CITY OF ALBUQUERQUE

RE: **1st Nations Community Healthsource**
5608 Zuni SE
Revised Grading and Drainage Plan
Engineers Stamp Date: 1/15/19
Drainage File: L18D047

Based on the submittal received on 2/6/19, the Grading and Drainage Plan cannot be approved until the following are corrected:

C-002

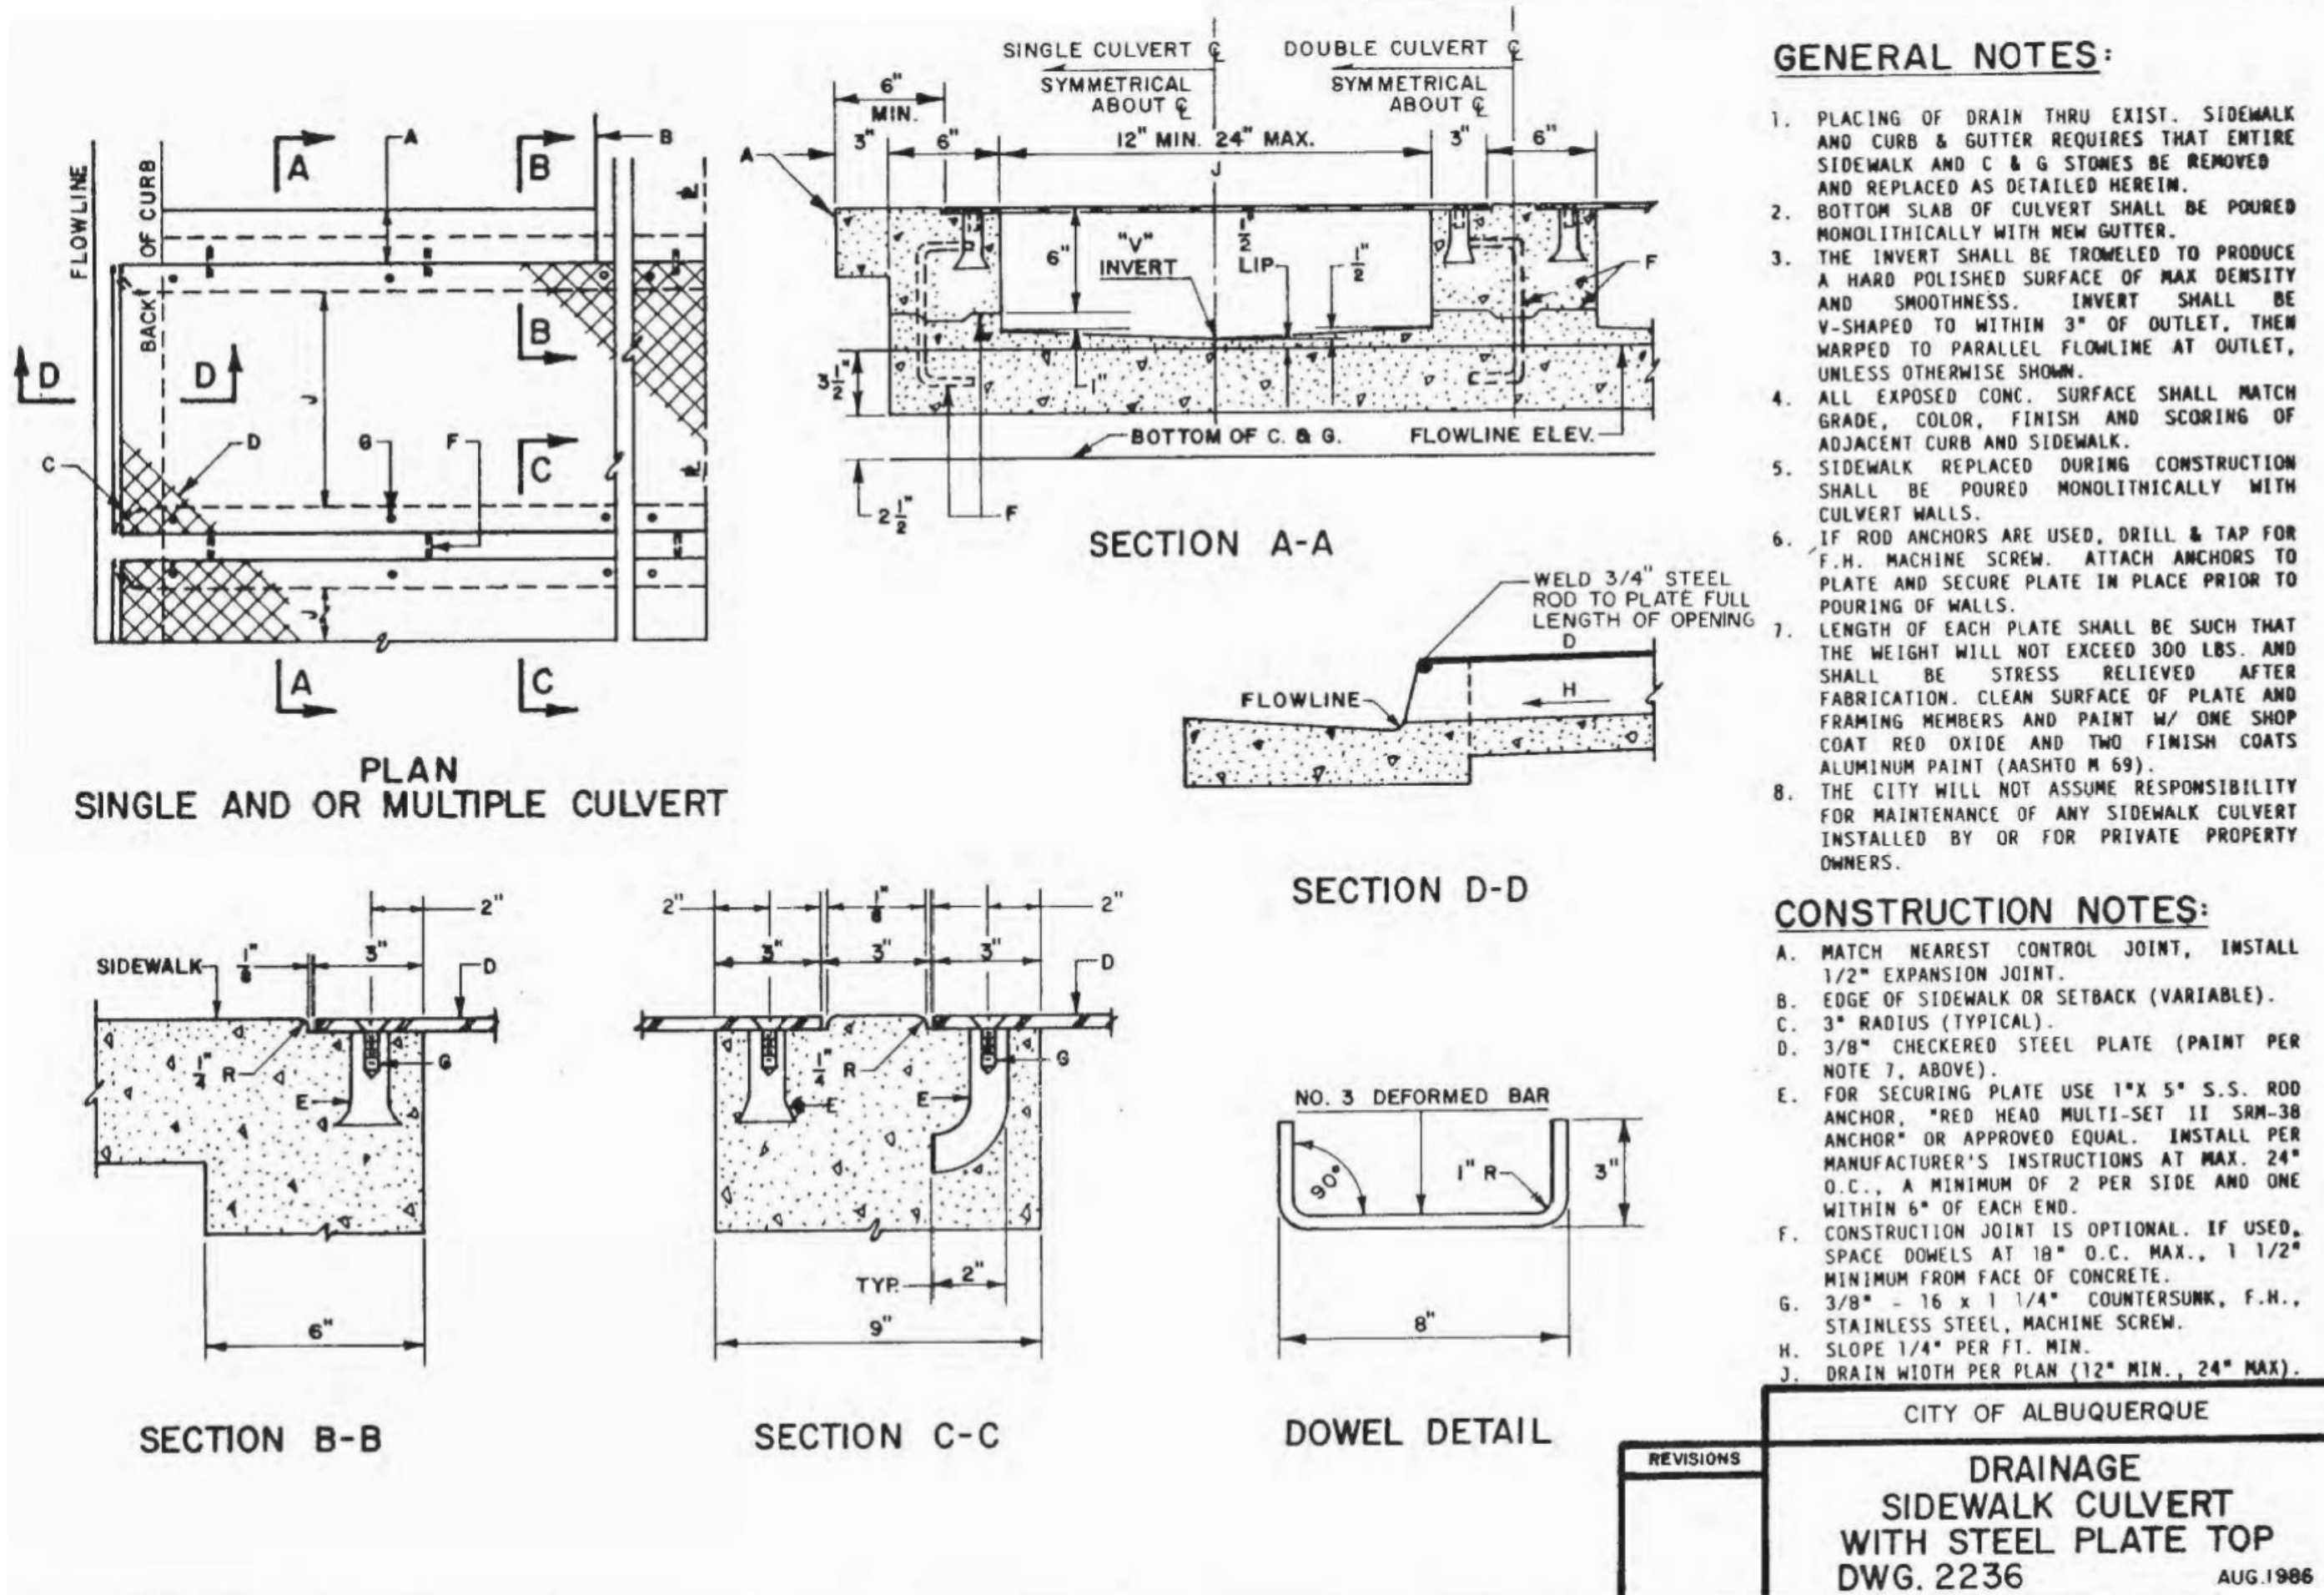
1. Because this is a resubmittal of a previously approved plan, the entire plan needs to be included; the grading and drainage plan for the east side of the site needs to be restamped and included. If any changes were made to the plan on the east side, these should be included.

2. The plan needs to clearly state: that the applicant could provide on-site management of the storm water quality volume (SWQV), that the applicant does not wish to provide on-site management, and is requesting to pay a fee-in-lieu of onsite management instead. This site could easily provide onsite retention by relocating utilities to accommodate a pond, by locating the pond under the parking lot (underground storage) or grading the parking lot to drain to another location where utility conflicts do not exist.

3. Payment of the Fee in Lieu (Amount = $207\text{CF} \times \$8/\text{CF} = \1656 , per sheet C-002) of onsite management of the SWQV must be made. Include a copy of the paid receipt when resubmitting.

4. An SO-19 Permit will be required; please include the [standard SO-19](#) notes on the grading plan. In Keyed Note 1, an excavation/barricading permit is also needed.

5. Include project benchmark and datum.
6. The engineer's stamp date needs to be updated with each resubmittal.
